US HIGHWAY 93 WHITEFISH WEST PROJECT

Re-Evaluation

US 93 Somers to Whitefish West

October 2008

FEIS Section J2

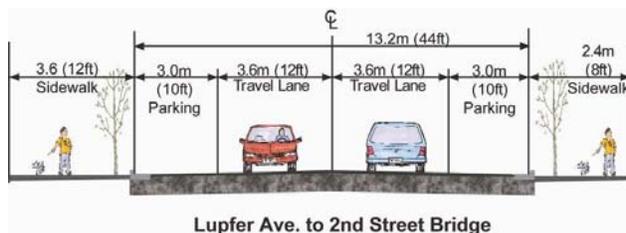
New or Revised Feature	Reason for Change
The lane configuration would be revised to two 3.6 m (12 ft) travel lanes, with 3.0 m (10 ft) parking lanes on each side. The overall width of the street would not change.	The City of Whitefish and the CWG expressed a strong desire to preserve downtown character and minimize impacts to businesses. The Current Proposed Action maintains the existing lane configuration pending the outcome of the Whitefish Urban Corridor Study.
Variable width sidewalks were shown in Section J1 in the FEIS.	This is not a changed condition.

FEIS Section K

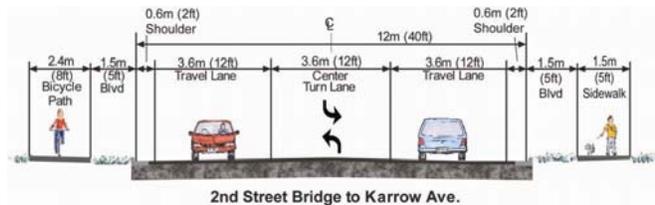
New or Revised Feature	Reason for Change
The travel lanes and the center turn lane would be reduced from 4.2 m (14 ft) to 3.6 m (12 ft).	The City of Whitefish and the CWG expressed a strong desire to promote lower speeds and minimize right-of-way impacts.
A 0.6 m (2 ft) shoulder would be added on both sides of the road.	The shoulder provides the necessary shy distance from the face of curb, and would be striped to give the appearance of a narrower lane.
1.5 m (5 ft) boulevards would be added between the curb and sidewalk where feasible. The addition of boulevards would increase the amount of right-of-way required.	Boulevards provide additional separation of pedestrians from vehicles, snow storage, and landscaping opportunity.

FEIS Section L

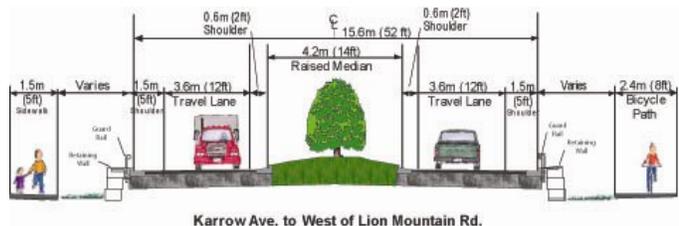
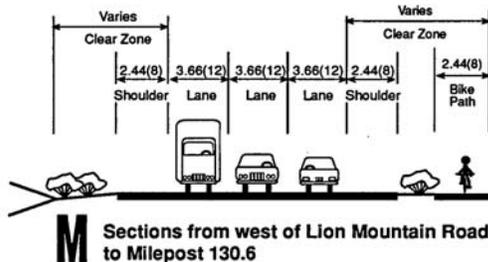
New or Revised Feature	Reason for Change
Raised median width would be reduced from 5.5 m (18 ft) to 4.2 m (14 ft) with 0.6 m (2 ft) inside shoulders. The outside shoulder width would be reduced from 2.4 m (8 ft) to 1.5 m (5 ft).	This change is proposed to avoid impacts to 4(f)/6(f) properties (golf club and park).
The intersection with Lion Mountain Road would be relocated approximately 90 m (300 ft) west of the existing intersection, including accommodation for a future signal and a new approach from the south.	This change is proposed to safely accommodate future access needs at Lion Mountain Road/State Park Road.

New or Revised Feature	Reason for Change
The sidewalk would be modified to a 2.4-m-wide (8 ft) shared bicycle/pedestrian path.	This change is proposed to provide a continuous bicycle path. A continuous separated bicycle path was identified in the FEIS, where feasible. The CWG and City of Whitefish indicated a strong desire to include the path throughout the project with grade separated crossings at appropriate locations.
An eastbound right-turn lane at Karrow Avenue would be added.	Traffic analysis indicated a right-turn lane is warranted at this location. This change is proposed to meet the purpose and need of the project, which is to improve overall safety conditions.

FEIS Section M

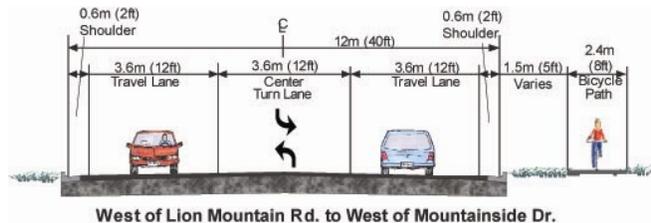
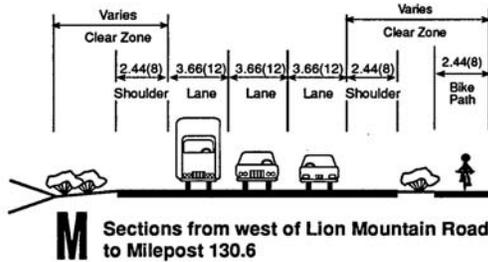
New or Revised Feature	Reason for Change
Curb and gutter would extend to station 32+00 (approximately 350 m (1,150 ft) west of Mountainside Drive).	This change is proposed to reduce right-of-way impacts to businesses and residences.
The eastbound truck climbing lane (approximately 805 m (2,600 ft)) would be eliminated and the westbound truck climbing lane would be shortened from approximately 1,448 m (4750 ft) to 483 m (1,584 ft).	This change is proposed to reduce right-of-way impacts to businesses and residences. Traffic analysis indicated that reducing or eliminating the truck climbing lane would have only minor effects on safety and operations.
A 3.6 m (12 ft) center turn lane would be added.	Traffic analysis indicated that a turn lane would improve safety by removing turning vehicles from the through lanes. This change is proposed to meet the purpose and need of the project, which is to improve overall safety conditions.

FEIS Section M

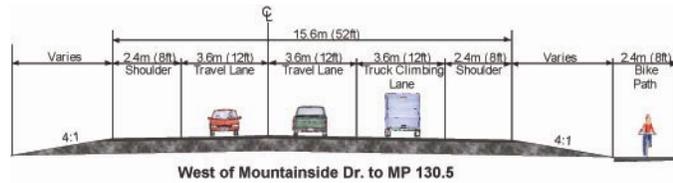
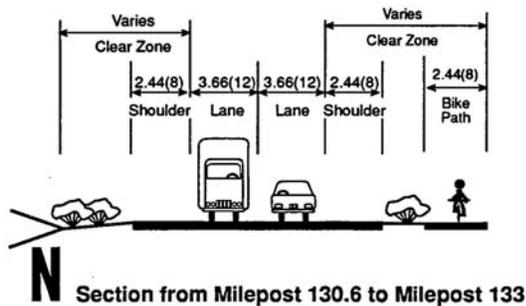
New or Revised Feature	Reason for Change
Left-turn lanes would be added at Mountainside Drive and Sasquatch Hollow/West Blanchard Lake Road.	Traffic analysis indicated that a turn lane would improve safety by removing turning vehicles from the through lanes. This change is proposed to meet the purpose and need of the project, which is to improve overall safety conditions.

FEIS Section N

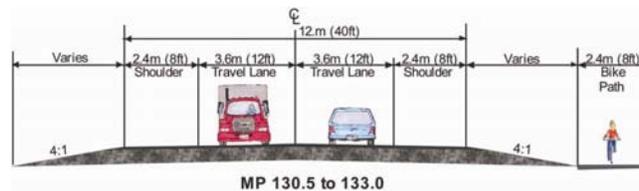
New or Revised Feature	Reason for Change
West of Skyles Lake, the bicycle/pedestrian path would be revised to cross US 93 and follow the highway on the south side. An underpass would be provided at this location. The bicycle/pedestrian path would be revised to end at Twin Bridges Road, where it would connect with the planned Whitefish Trail System.	This change is based on input from the City of Whitefish and the CWG to provide improved safety for path users, better connections to recreational areas at Spencer Lake, and better integration with the planned Whitefish Trail System.
A westbound left-turn lane at Whitefish Hills Drive would be added.	This change is proposed to meet the purpose and need of the project, which is to improve overall safety conditions.
